**ADDENDUM TO RFP DOCUMENTS**

<b>SOLANO</b> COMMUNITY COLLEGE 	ADDENDUM #01
	Project: #16-015 Solano Community College District Site Lighting Improvements Project
	Date: March 29, 2016

**ITEM NO. 1 – PLAN SHEET 0.00 – COVER SHEET, INDEX**

⑤ SITE LIGHTING POLE BASE  
NOT TO SCALE

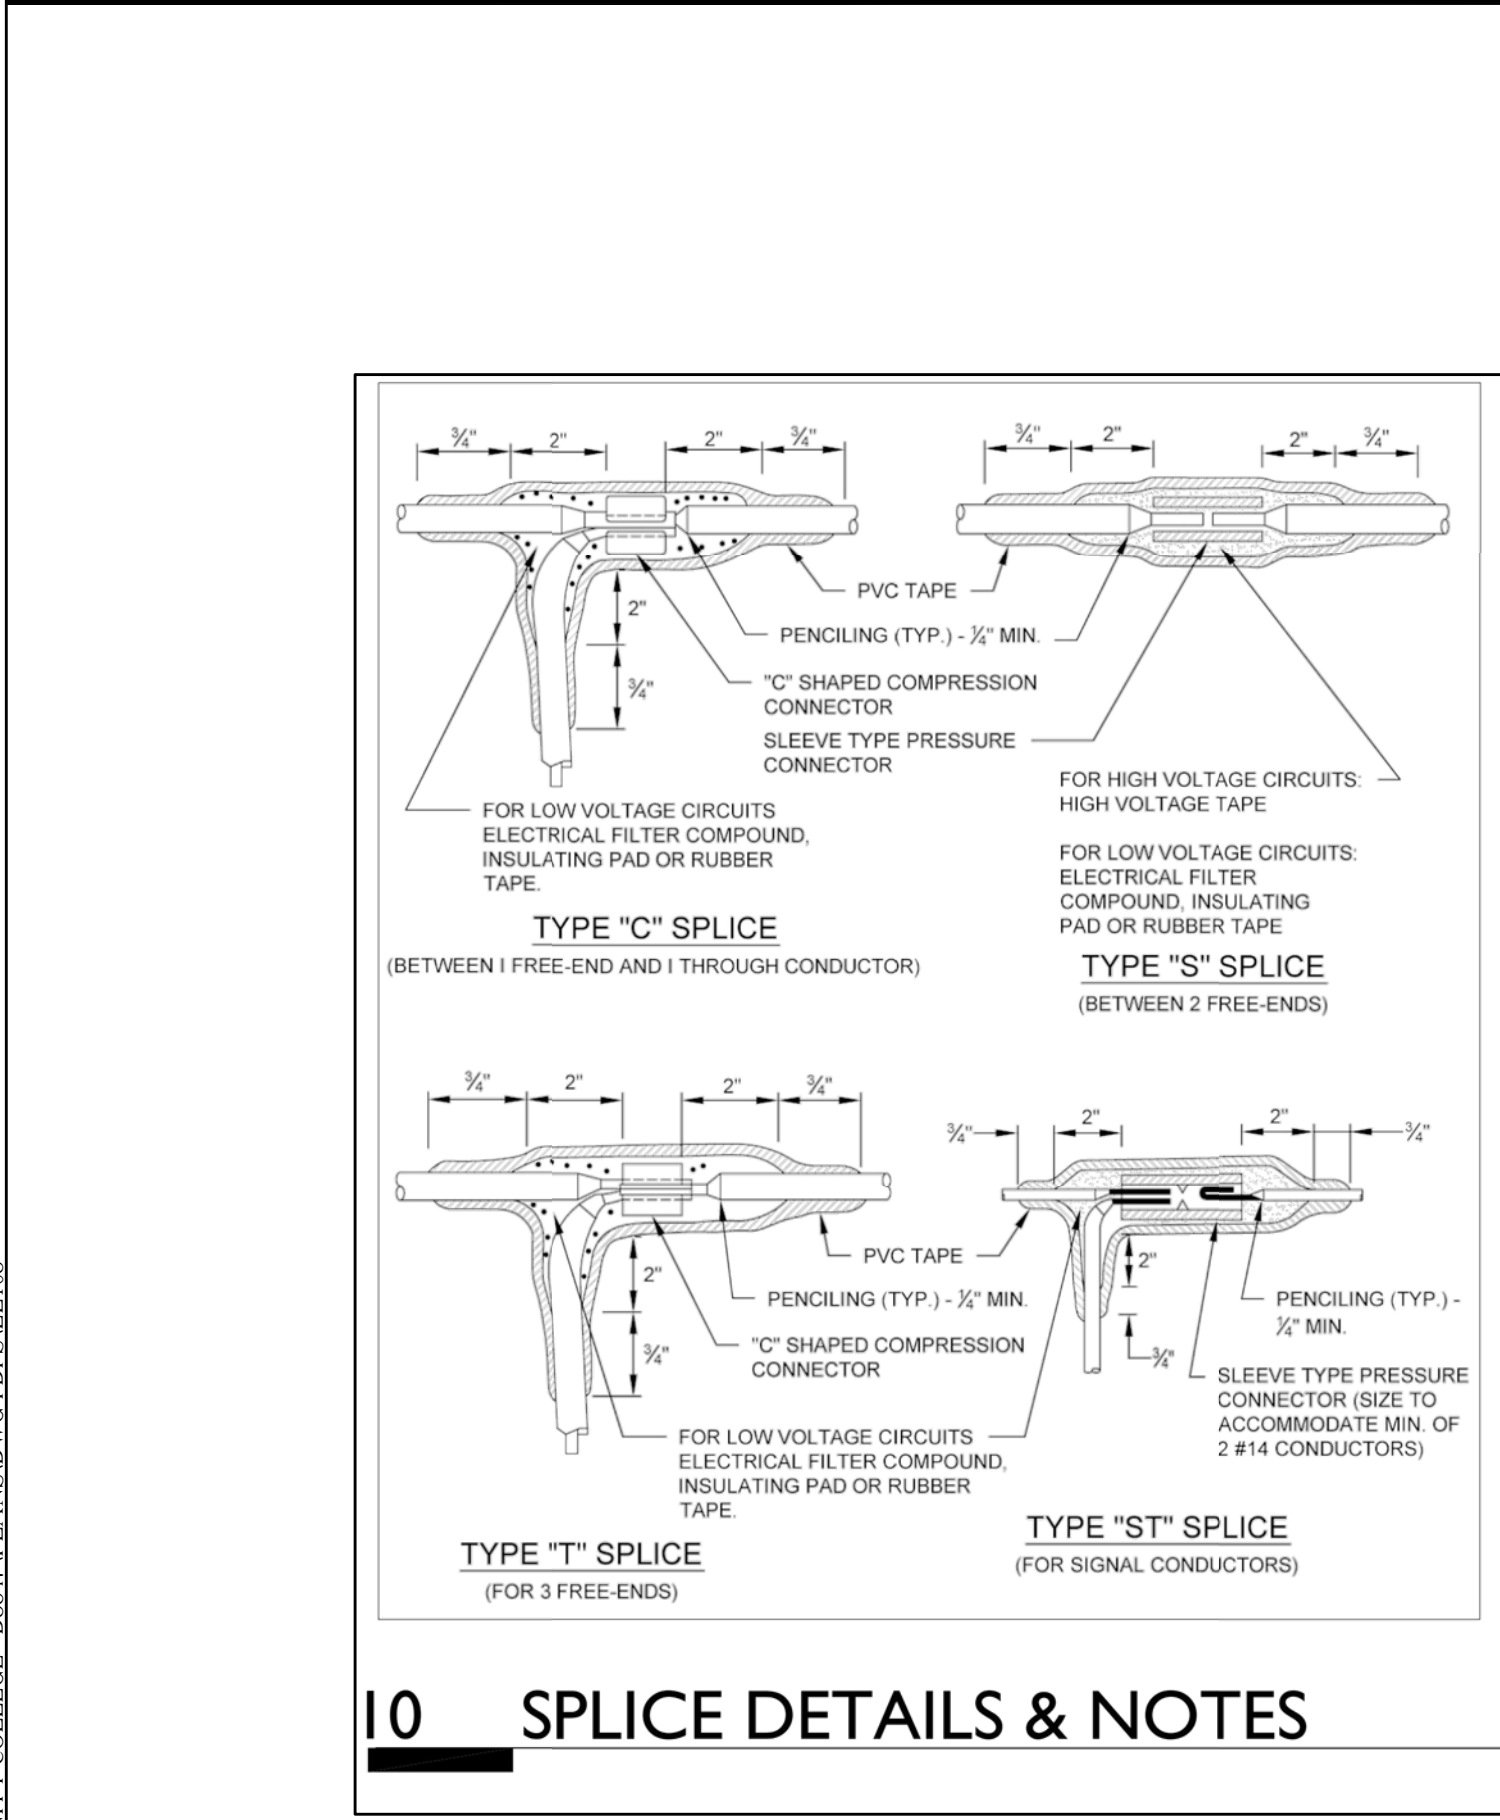
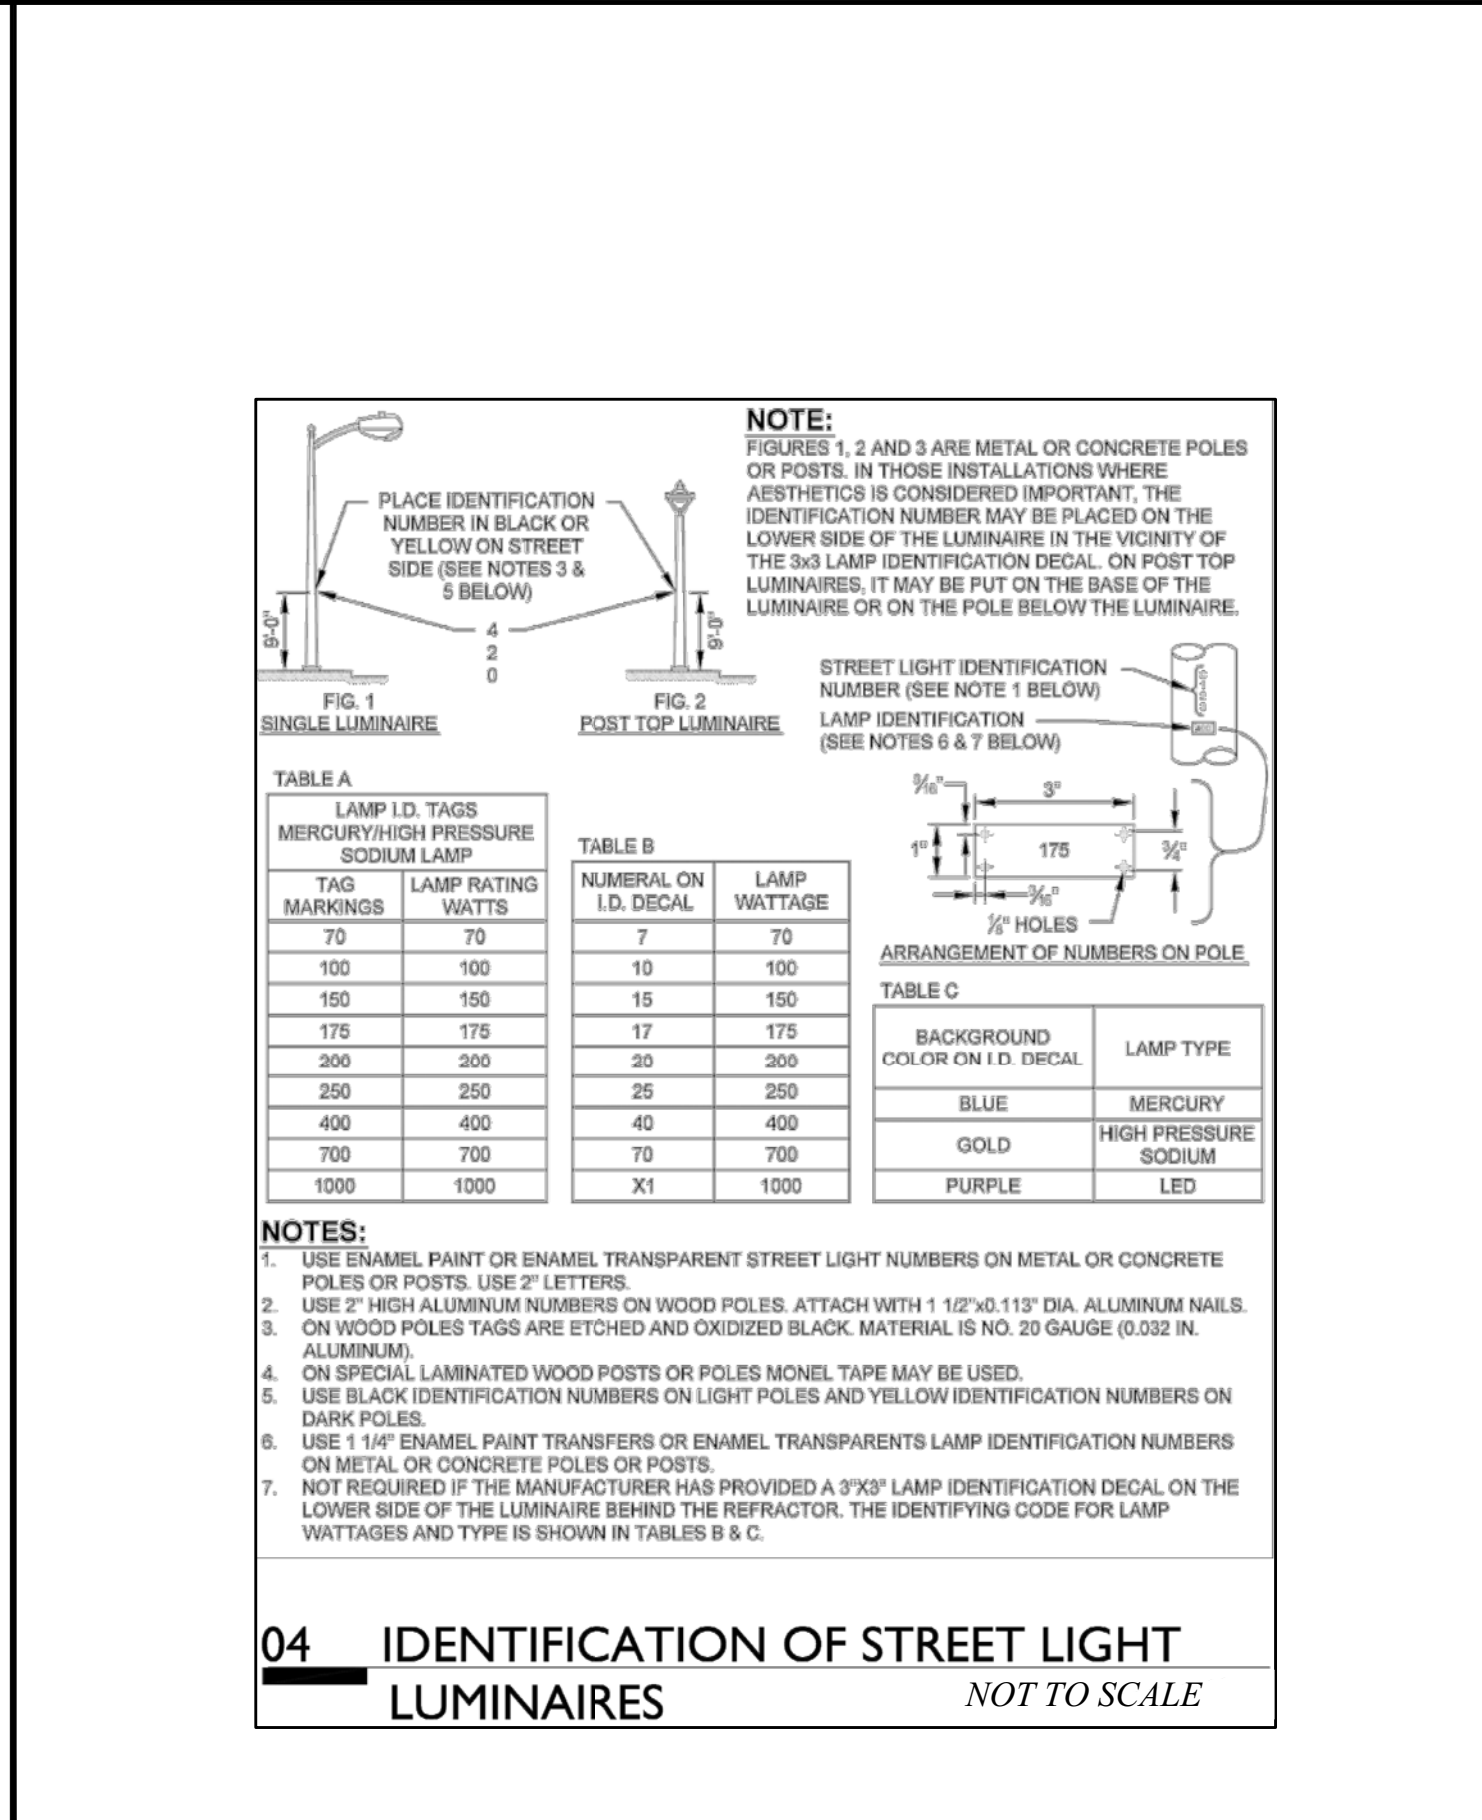
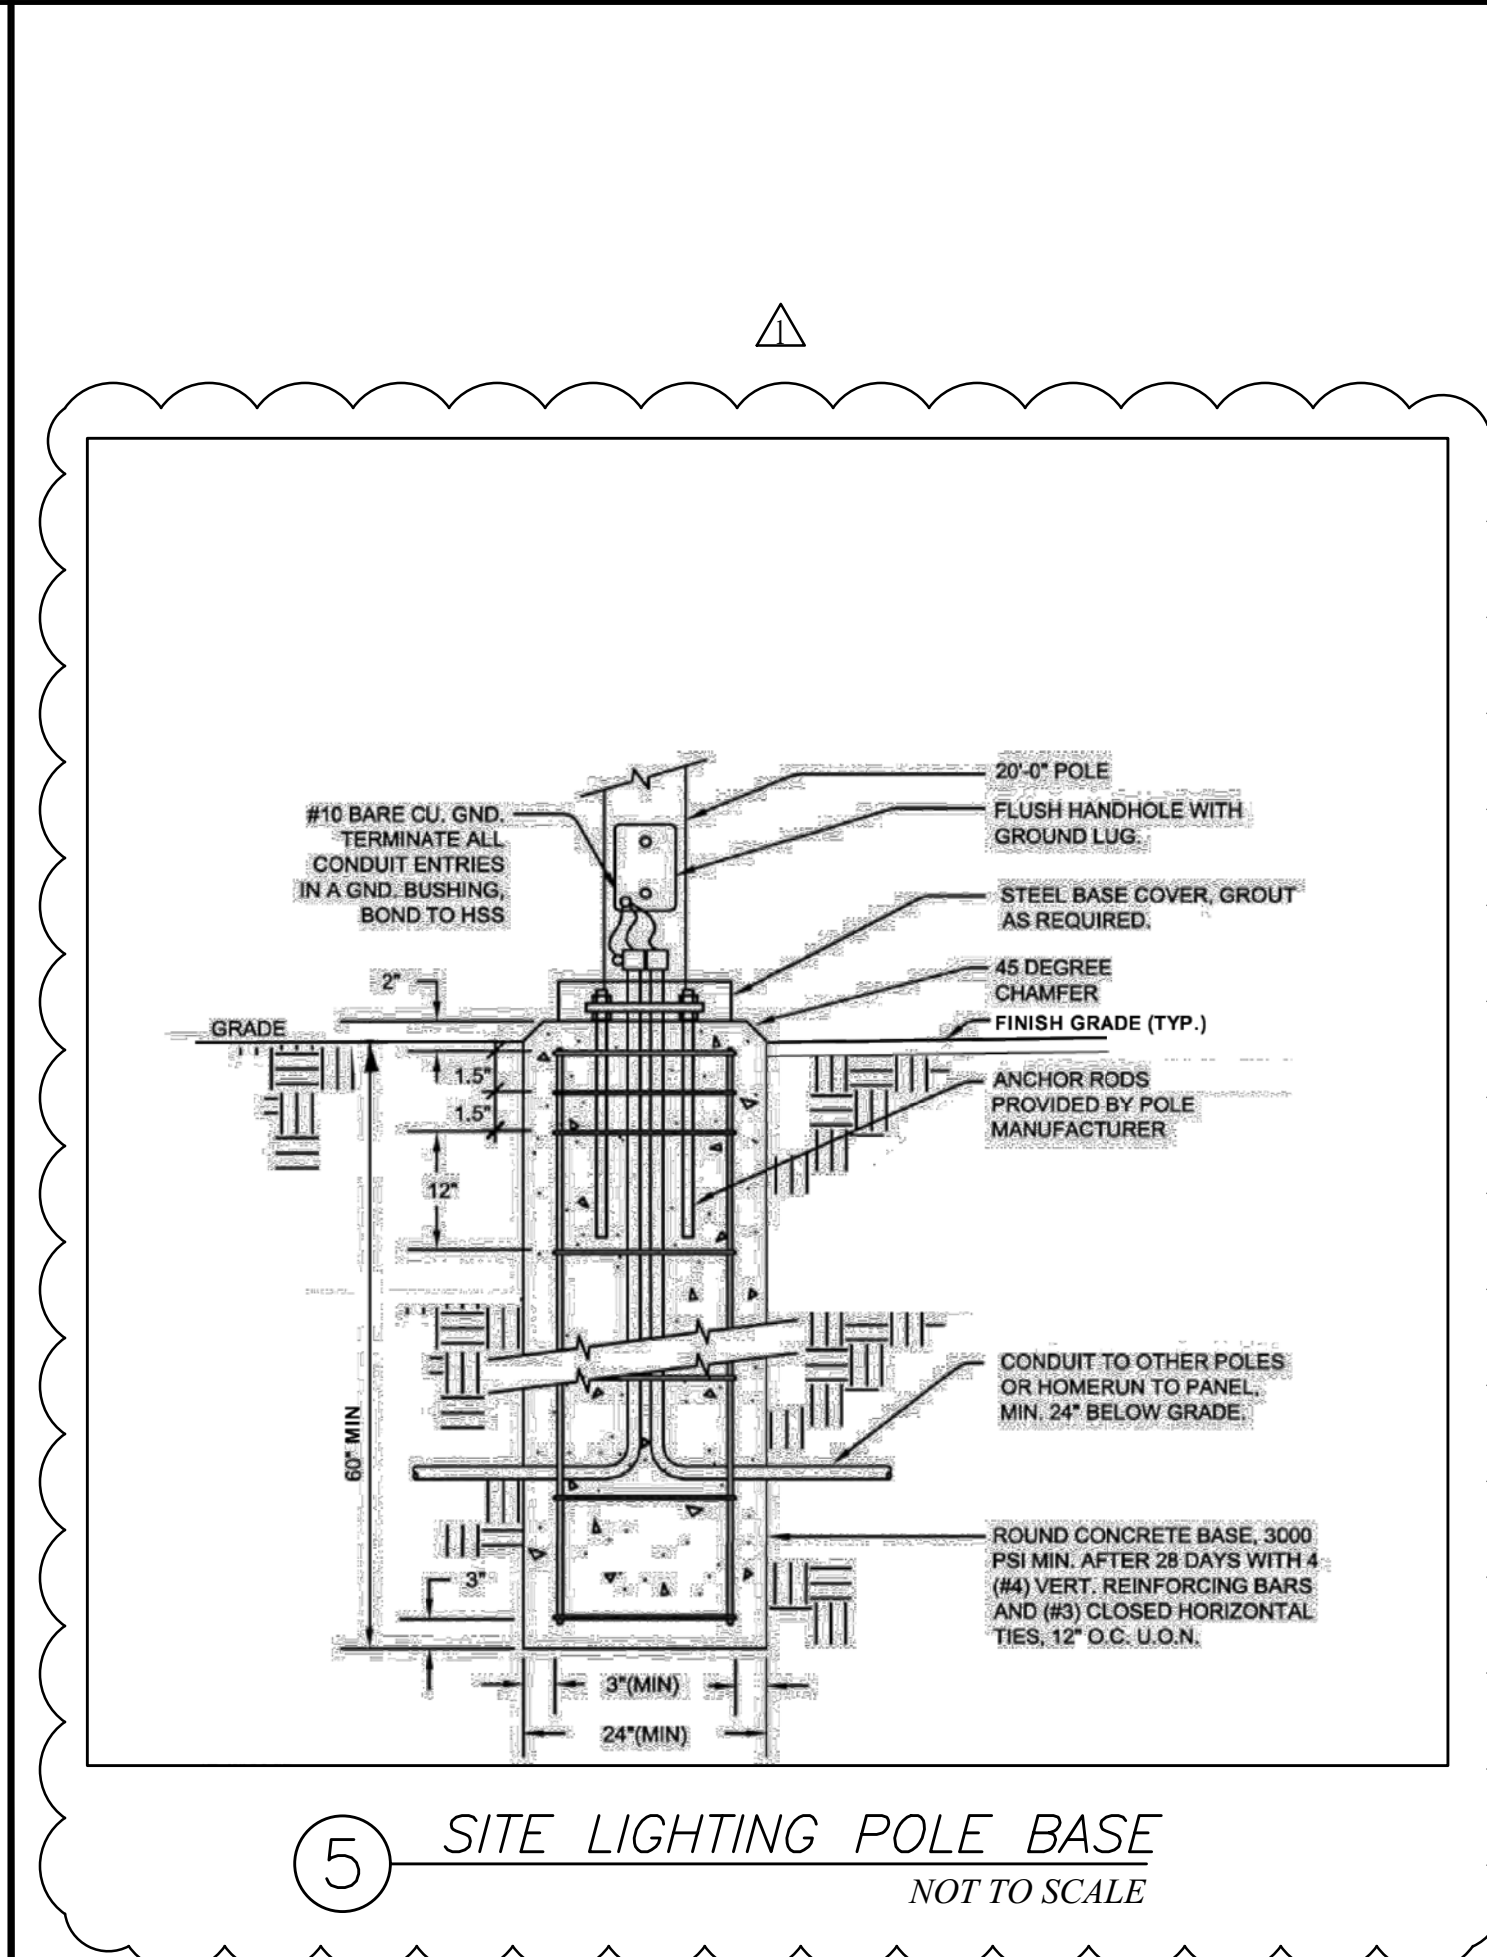
**ITEM NO. 5 – PLAN SHEET EL 103 – INSTALLATION DETAILS**

Replace 'Plan Sheet EL 103' with attached revised 'Issue for Addendum #1 3/30/16 – Plan Sheet EL 103'. Revisions include the following:

- Delete detail 'Cast-In-Place Lighting Foundation' and replace with 'Site Lighting Pole Base'.
